NORTHERN STATES POWER COMPANY

MONTICELLO NUCLEAR GENERATING PLANT
Docket No. 263 License No. DPR-22

Redundant Reactor Building Crane

Responses to Request for
Additional Information

FIGURE 1

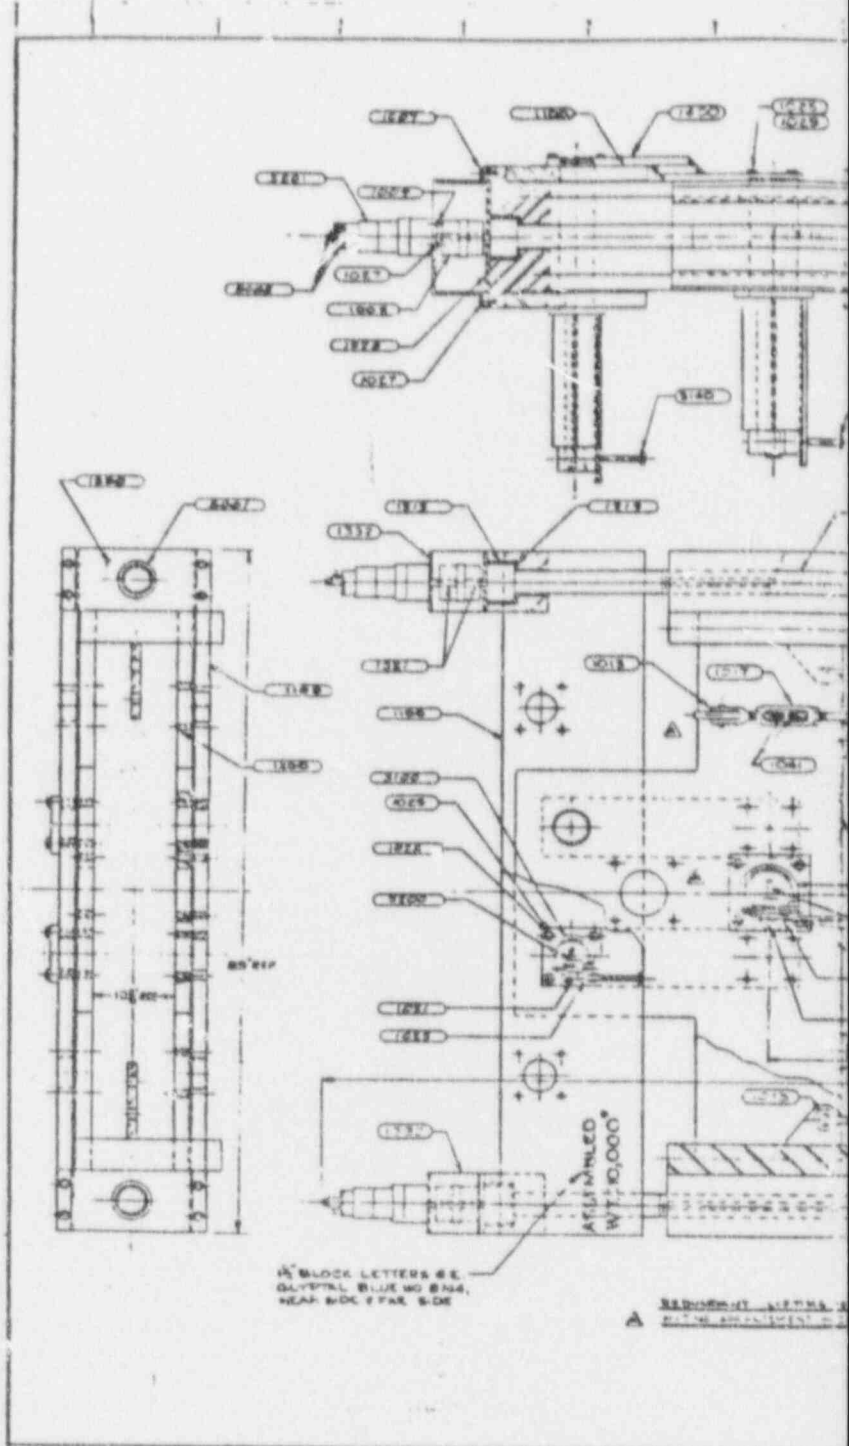
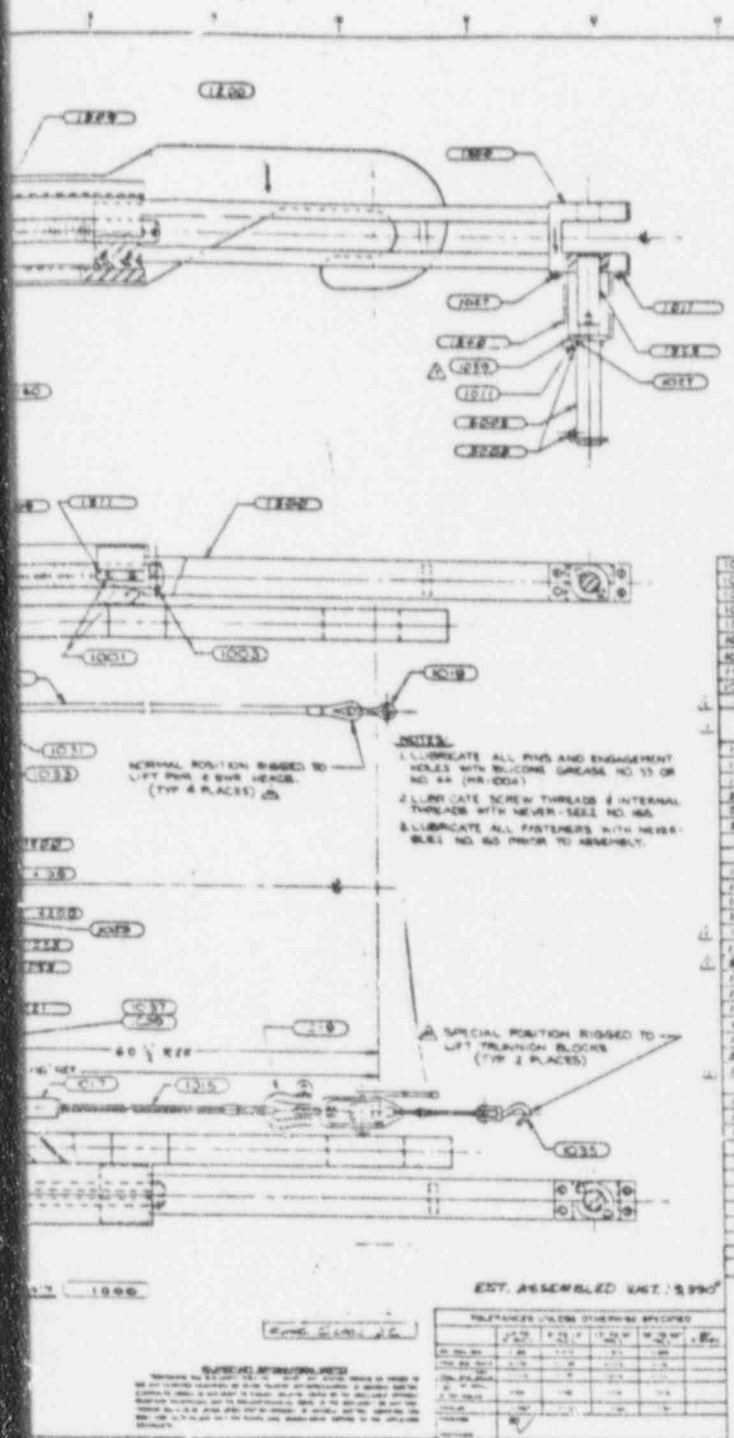
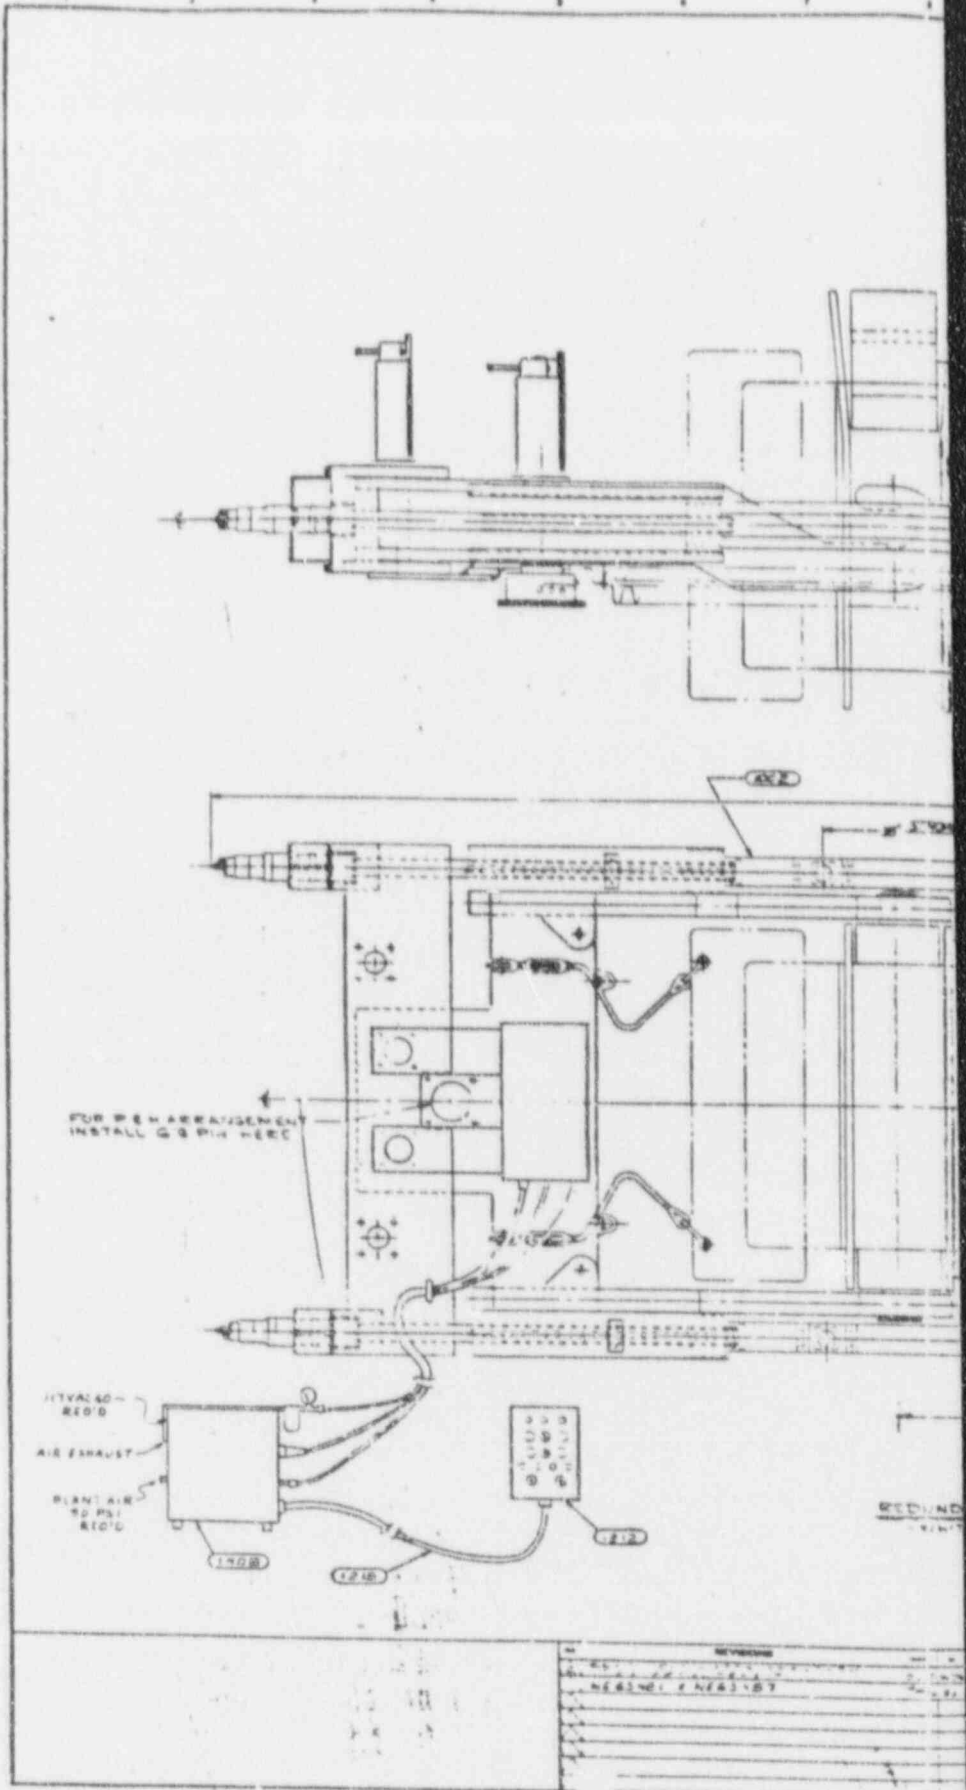
QUESTION 8: Indicate which of the two IF-300 shipping cask handling yokes will be utilized in the Monticello Nuclear Generating Plant. Discuss and compare the relative merits and disadvantages of the two handling yokes as their requirements relate to the limitations at your facility.

RESPONSE 8: Northern States Power Company will use the "redundant IF-300 cask yoke". The non-redundant yoke will not be used. Drawings of the redundant yoke are shown in Figures 1 and 2.
